Charlotte Department of Transportation

Memorandum

Subject: Rezoning Petition 16-016: Approximately 4.3 acres located on the northwest corner at the intersection of North Davidson and East 26th Street

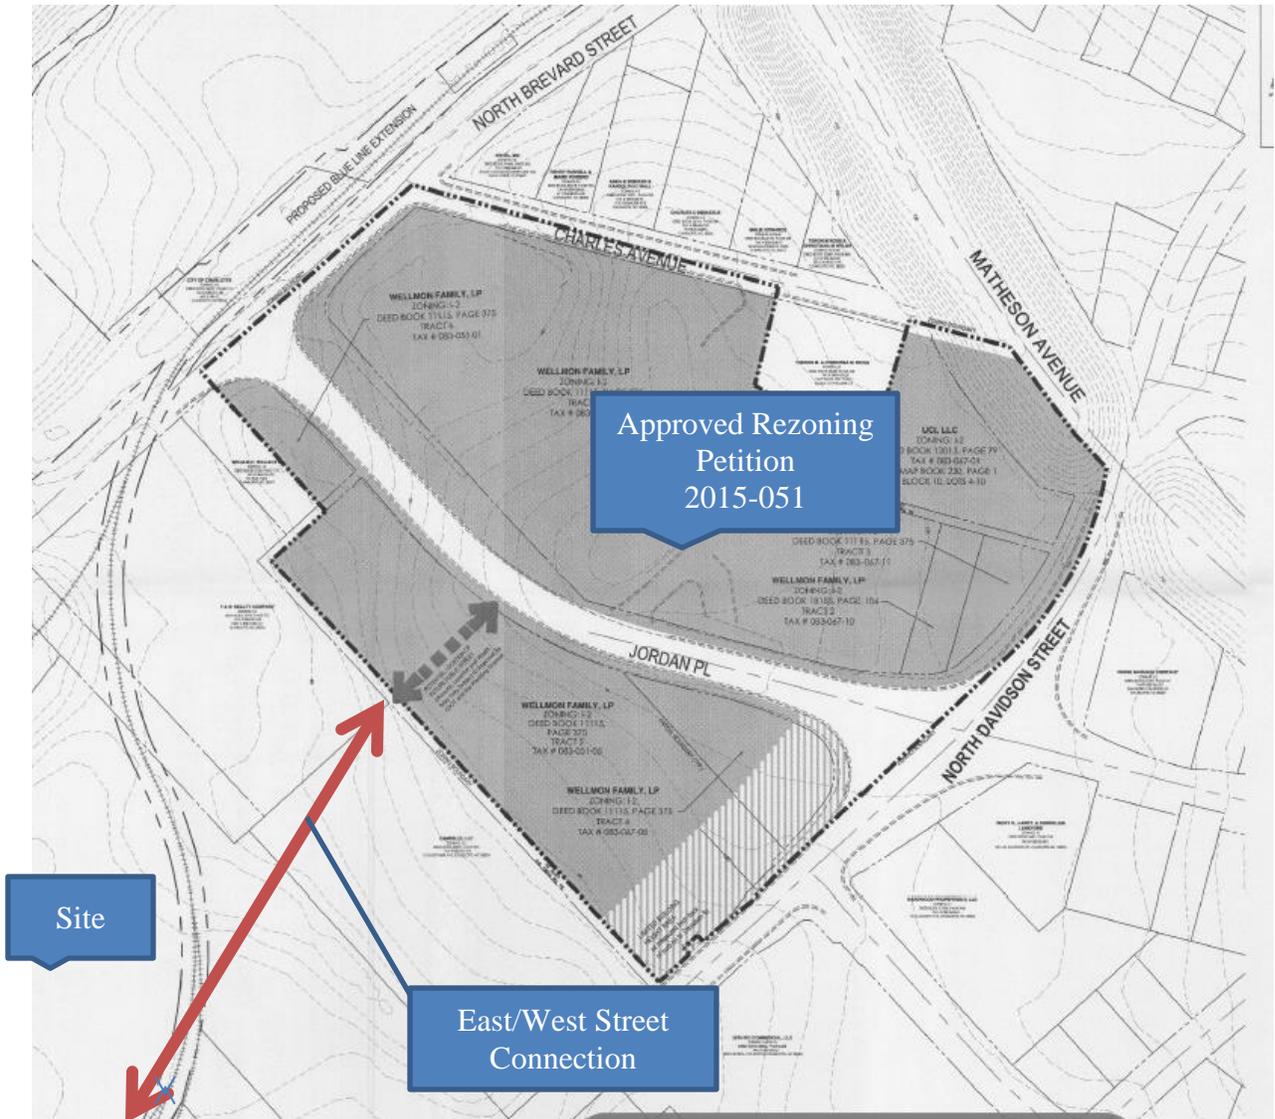
1. The Petitioner needs to revise the site plan to depict an east/west street connection through the site to connect to 26th Street and a future street stub from Jordan Place required by petition 2015-51 (See below exhibit). We recommend the petitioner provide more detailed information regarding the site's proposed land use(s) so that the future street connection can be properly sized, to include on-street recessed parking. Without further information the east/west street connection through the site should be a Local Office/Commercial Wide typical street section (See CLDSM U-05A). This East/West Street connection needs to be implemented and platted before the site's first building's CO is issued.

2. The Petitioner needs to revise the site plan to depict and reserve right-of-way for the planned Cross Charlotte trail (XCLT) project. The City's XCLT team has recently reviewed the trail's proposed alignment and right-of-way needs with the petitioner/developer (see below exhibit showing XCLT proposed alignment).
